Hampstead Heath, Highgate Wood and Queen's Park Committee

8. **HAMPSTEAD HEATH PONDS PROJECT - ASSESSMENT OF THE DESIGN FLOOD**
Report of the Superintendent of Hampstead Heath (copy attached).

Figure 4-1 Hampstead and Highgate FEH Catchment Boundary Map

Figure 4-3 Hampstead Chain Boundary Map

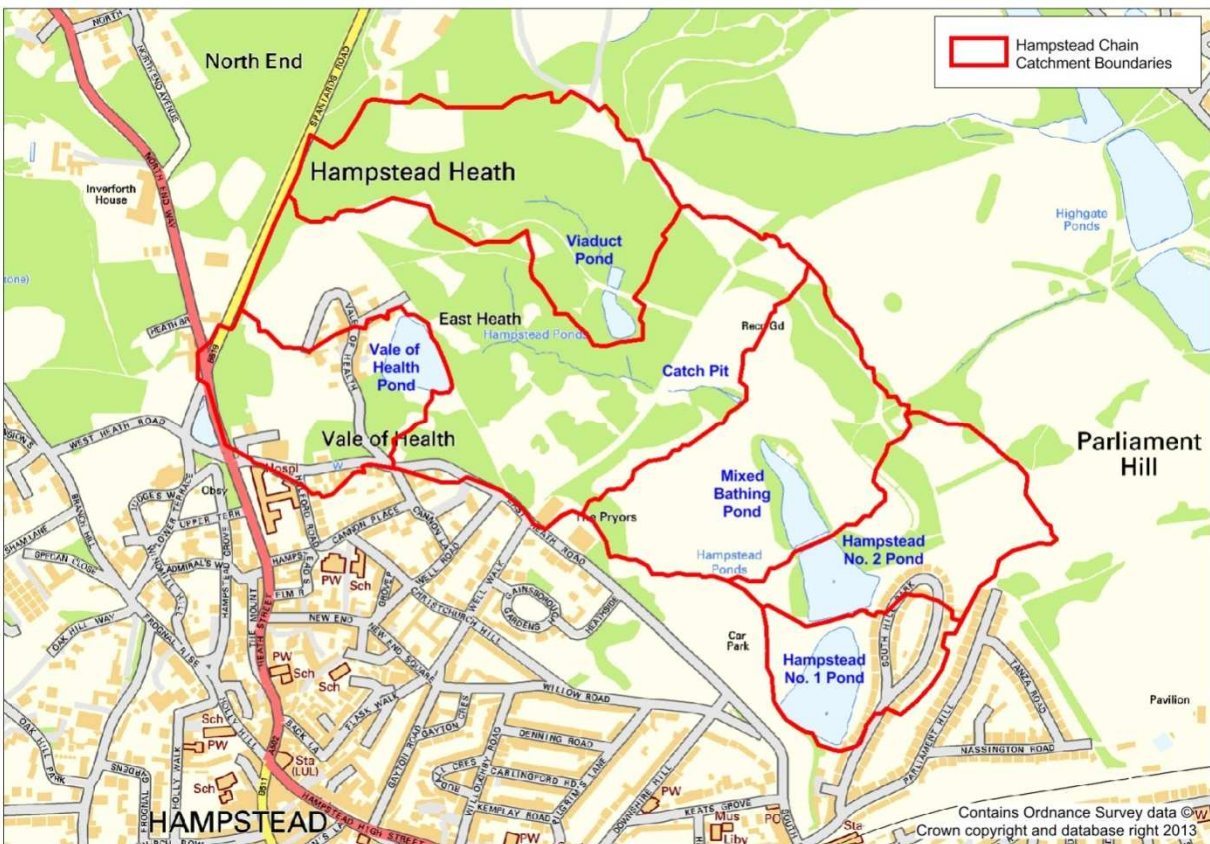
Q6. Ian Harrison has questioned whether the catchment boundaries shown in Figures 4-2 and 4-3 have been drawn correctly as visual observations on the ground

suggested more water would flow to Vale of Health Pond and less to Catch Pit than suggested by the boundary shown on Figure 4-3.

Figure 4-5 24-hour Rainfall Depth Frequency Curves

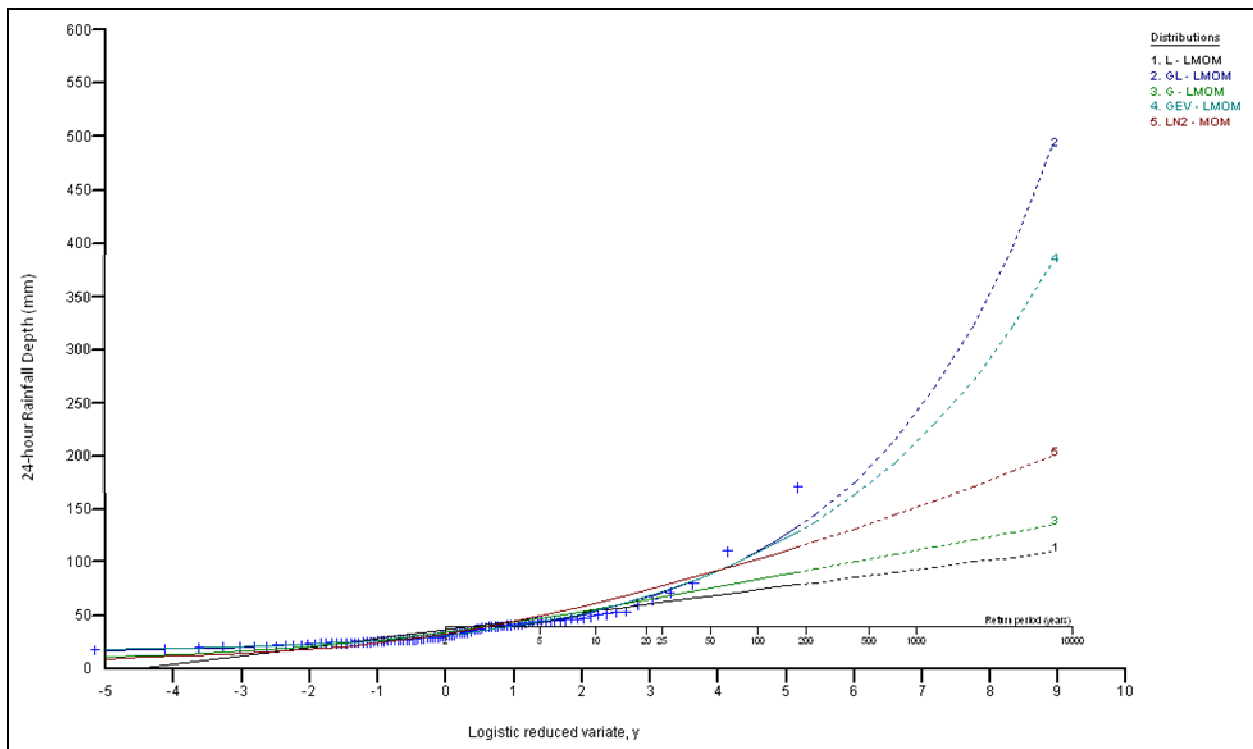
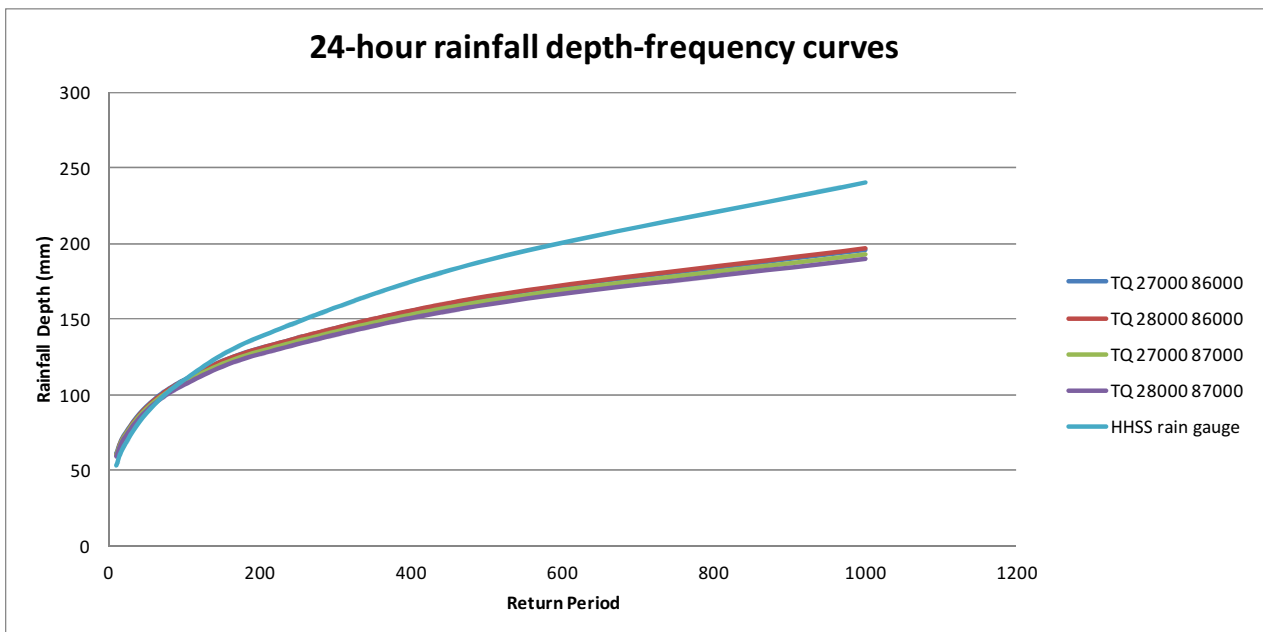
Originating Group and date	Query	Atkins Response 12/04/13	City of London Corporation Response 18/04/13
Fitzroy Park RA 20/03/13	Can we have more specific detail of exactly how much local data was integrated into the Atkins macro model for calculating the quantum? What local weighting did they integrate into to this new calculation?	<p>“Local” data was integrated as follows: For the estimation of the percentage run-off the soils map for Hampstead Heath was used to adjust the Standards Percentage Run-off which was provided by the automated routine with the FEH CD ROM. The HHSS rainfall record was analyzed and it was demonstrated that it was statistically inconsistent with the information from FEH. This is to be expected as it is statistically unreliable to apply data from a single rainfall gauge and with a short record length in comparison with the events being predicted (see Figures 4-4 and 4-5 in the main report).</p>
